SOUTH CAROLINA ELECTRIC & GAS COMPANY

May 30, 1984

Subject: Virgil C. Summer Nuclear Station
Docket No. 50/395
Operating License No. NPF-12
Spent Fuel Pool Rerack Modification

FIG. 2-1 MODULE LAYOUT

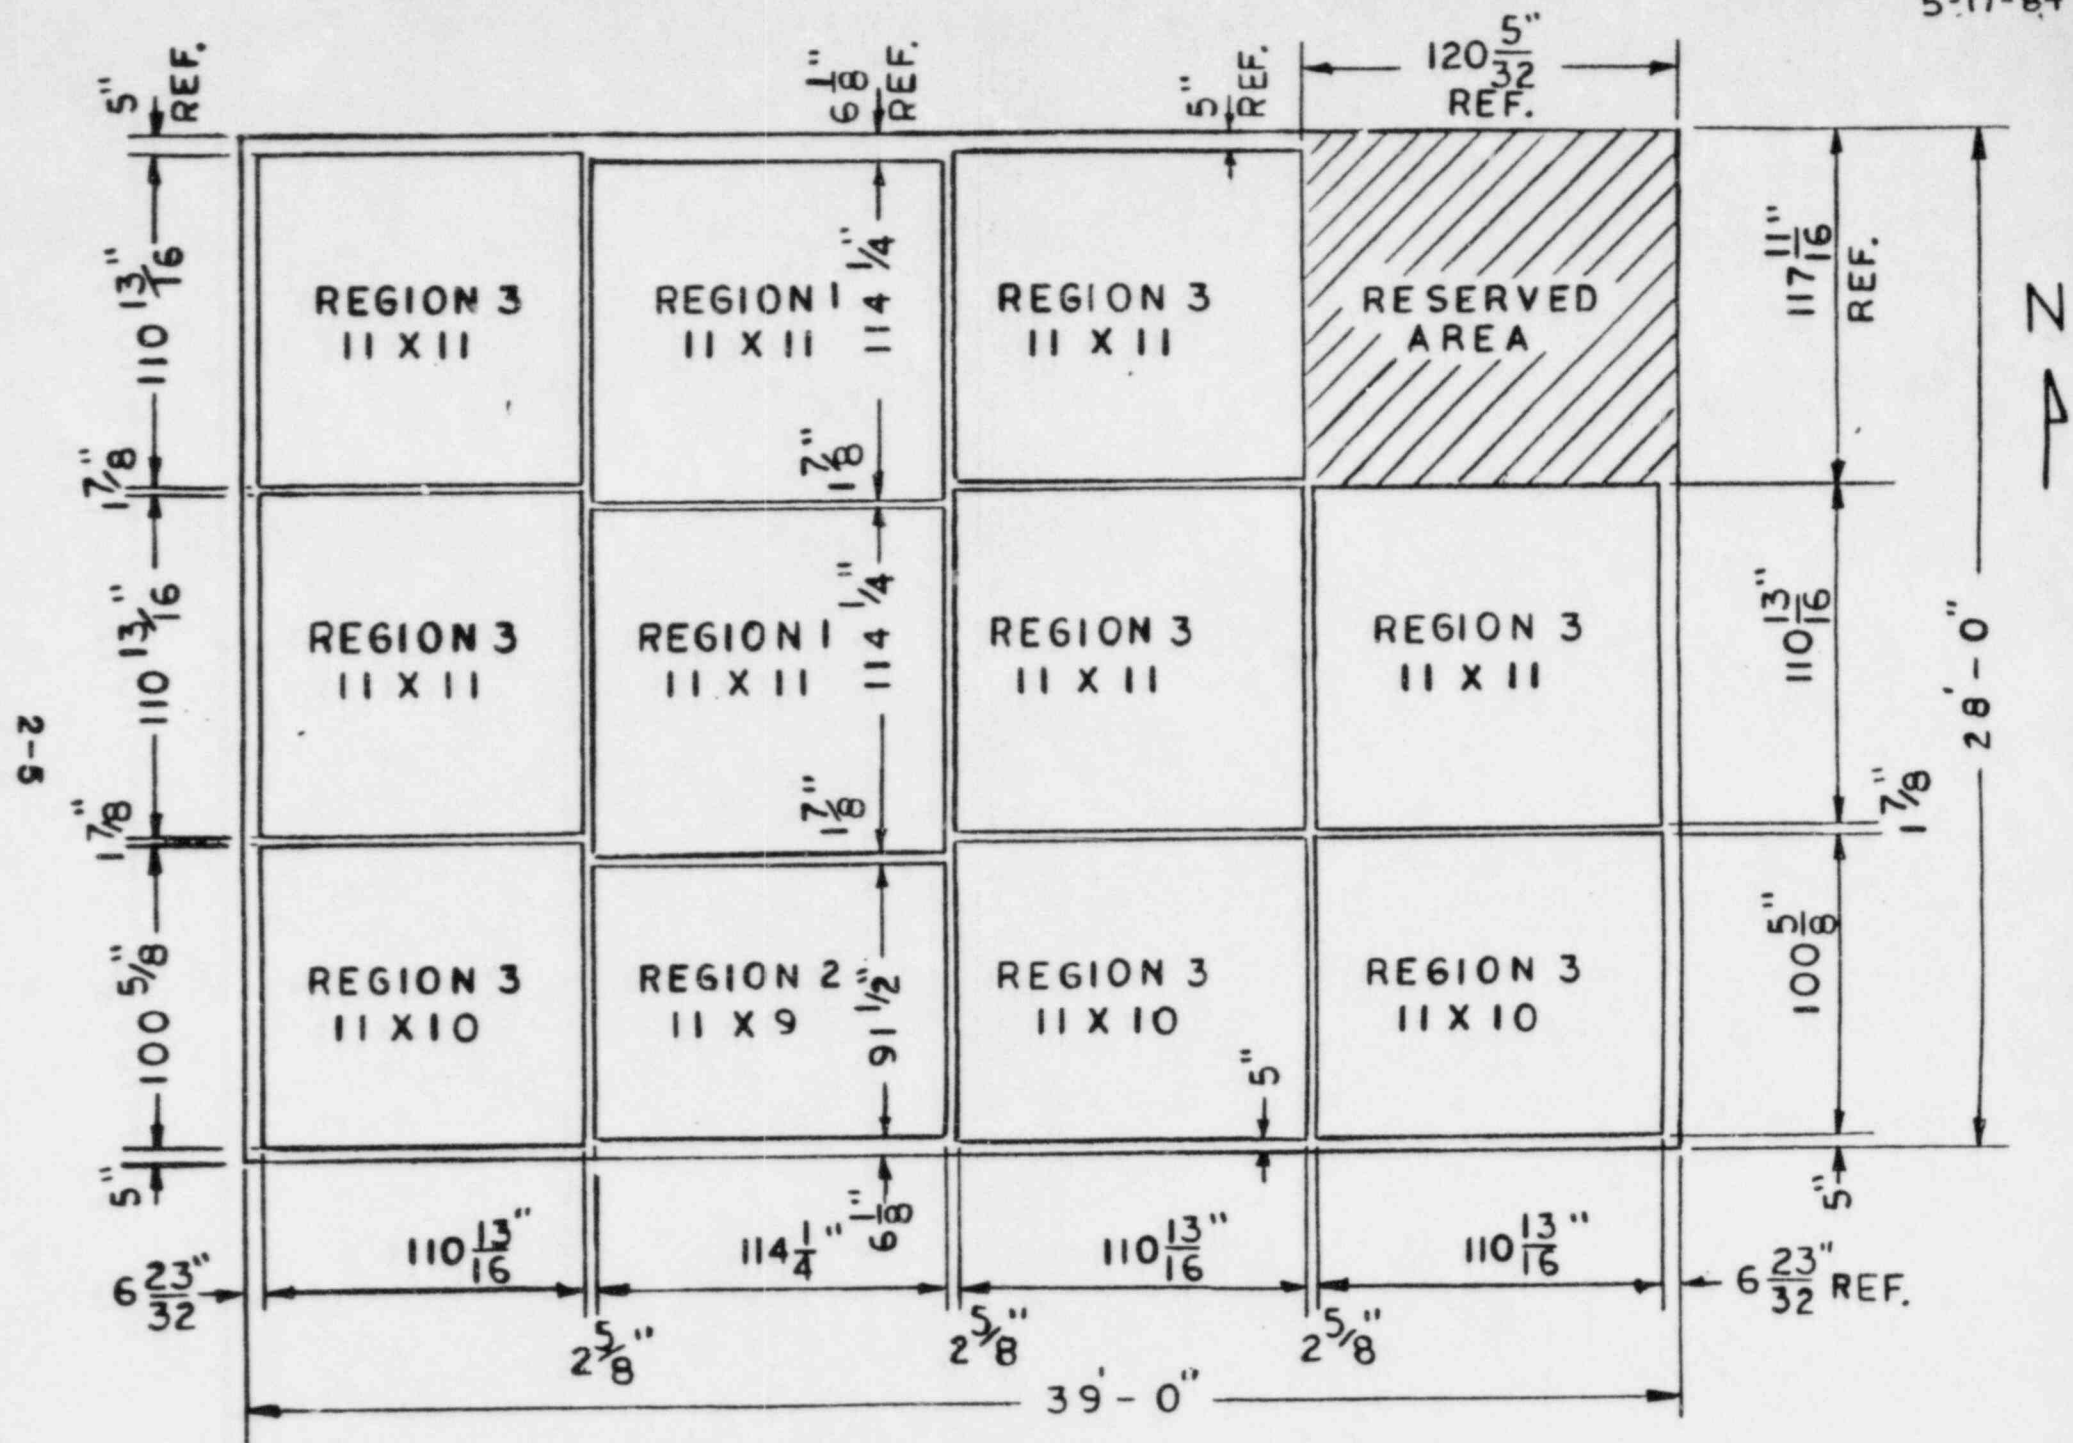
The first question concerns the possibility of relocating the Region I and Region II storage racks (poisoned racks) such that mechanical or electrical interlocks could be used to preclude inadvertently placing fuel assemblies in Region III (unpoisoned rack) storage locations. SCE&G does not consider the position of the poisoned rack regions to be a safety concern. Fuel assembly placement in the new rack modules is to be controlled administratively by Fuel Handling Procedures. Fuel transfers will be performed and verified using indexed location numbers to ensure that spent fuel assemblies are placed in the correct storage location. A critical arrangement by misplacement of a fuel assembly into Region III is precluded by the Technical Specification requirement that the pool be highly borated and periodically sampled during refueling operations. Because the seismic design of the proposed rack configuration would be invalidated by repositioning the racks, and because of the existence of strict administrative controls to preclude mispositioning a fuel assembly, SCE&G does not consider the addition of interlocks necessary to increase the margin of safety.

The fourth question concerns the possibility of heavy loads being moved into the area of the spent fuel pool designated as the "Reserve Area" (see Figure 2.1, enclosed). This "Reserve Area" can not be used as a cask loading area. The Fuel Handling Building crane is not capable of traveling over the spent fuel pool. Only the fuel handling machine can be operated over the area of the spent fuel pool. The "Reserve Area" would be used for operations, i.e., fuel sipping, assembly reconstitution, etc.
